Amendments to the Drawings:

The attached sheets of drawings include changes to Page 1 and Page 2 with changes to Fig. 1A and Figs. 2 and 3. In Fig. 1A the drain pipe 34 is drawn as L-shaped consistent with Fig. 3 and numerals have been added. In Figs. 2 and 3, numerals have been added.

REMARKS/ARGUMENTS

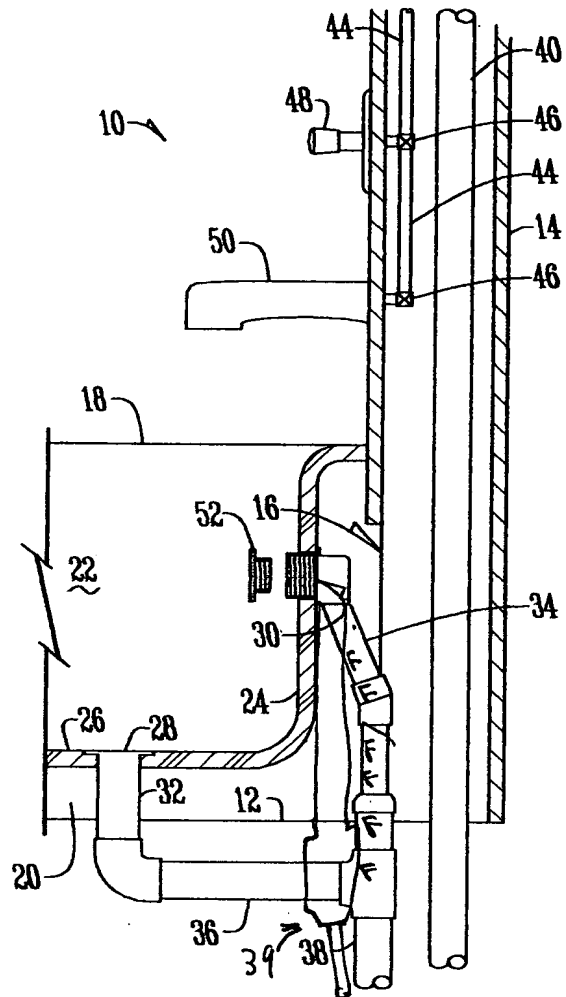
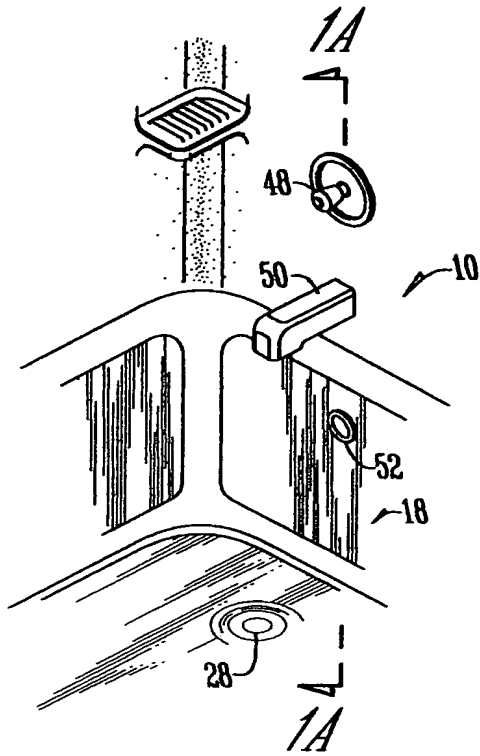
Once again, Fig. 3 shows the inverted L-shaped drain pipe with a horizontal leg 37A and a vertical leg 37B. Furthermore, Fig. 1A has been amended to show the embodiment of Fig. 3 wherein the drain pipe has an inverted L-shape wherein the horizontal leg extends through the overflow port and the vertical leg extends downwardly for connection to a fluid drain system.

The drawings have also been objected to as not showing "a fluid drain system". As discussed above, a numeral has been added to Fig. 1A showing the fluid drain system that was provided in the drawings of the original application. The specification has also been amended to call for the fluid drain system as described in the original claims. Thus, the drawing objection is considered overcome.

Fig. 3

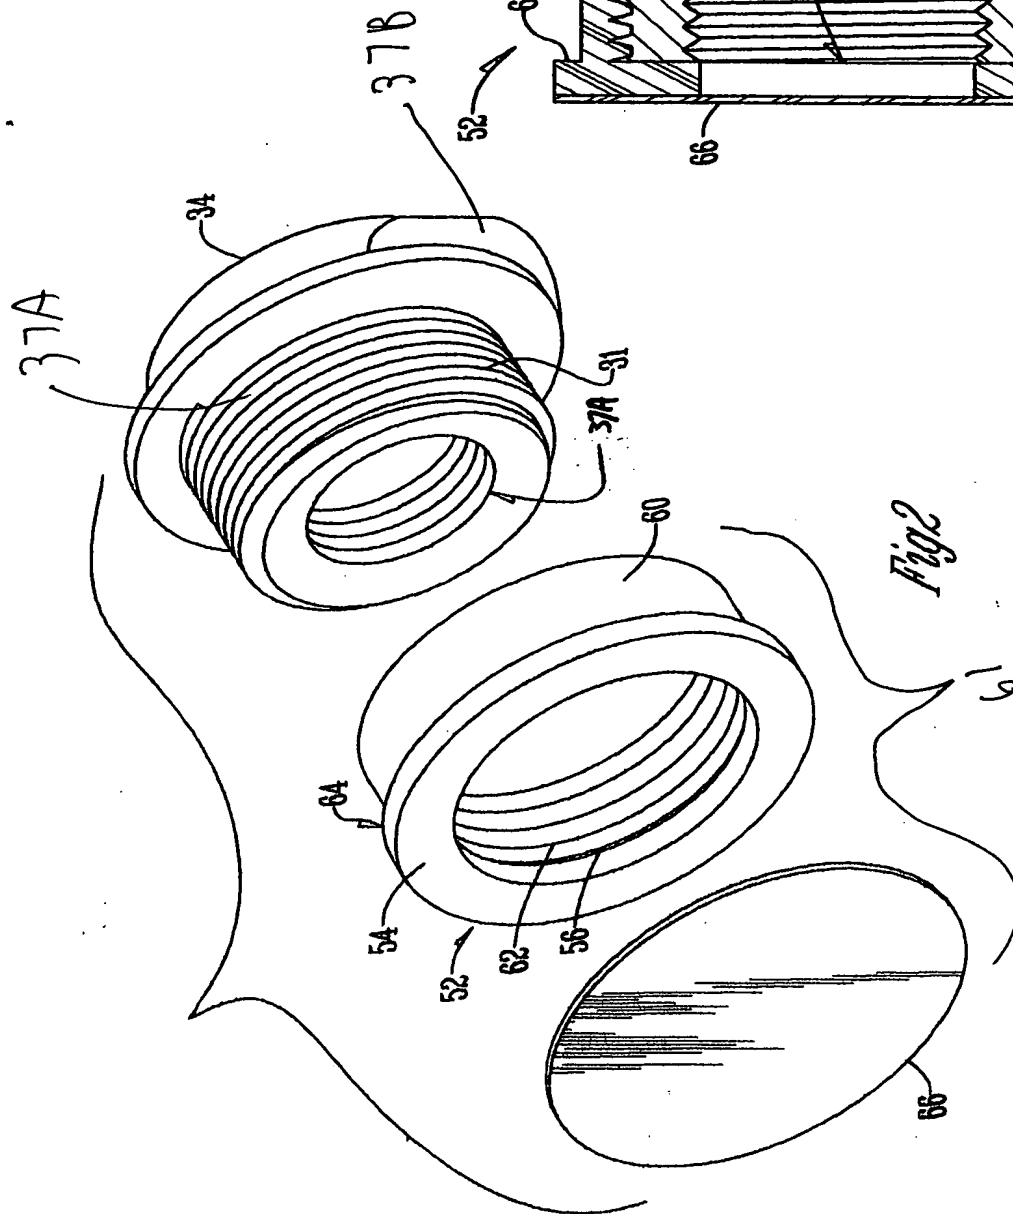
The drawings are objected to under 37 CFR § 1.83(a) as not showing every feature of the invention specified in the claims. First the Examiner asserts that the drawings do not show "a drain pipe having an inverted L-shape" as called for by claim 1. Applicant directs the Examiner's attention to Fig. 3 that shows a drain pipe 34 with an inverted L-shape having a horizontal leg 37A and a vertical leg 37B. Fig. 1A has been amended to specifically show this embodiment of the invention in all of the Figures. Thus Applicant asserts that the figures do show a drain pipe having an inverted L-shape and respectfully requests the drawing objection be withdrawn.

The Examiner has also objected to the drawings as not showing "a sealing material is composed of a material capable of sealing the first end when the cap is threaded onto the first end". This limitation has been amended to require "the cap threadably mounted on the externally threaded portion of the first end such that the cap is sealed against the overflow port when the cap is threaded onto the first end". This amendment gains its antecedent basis in the specification at page 4, lines 14 through 18 that state "a thin sealing membrane 66 is affixed to the face 54 (Fig. 2) of cap 52 so as to seal the aperture in the cap when it is screwed into the threads 31 so that the cap can be effectively sealed against the port 30". Thus no new matter has been added. Additionally, Fig. 3 shows this sealing
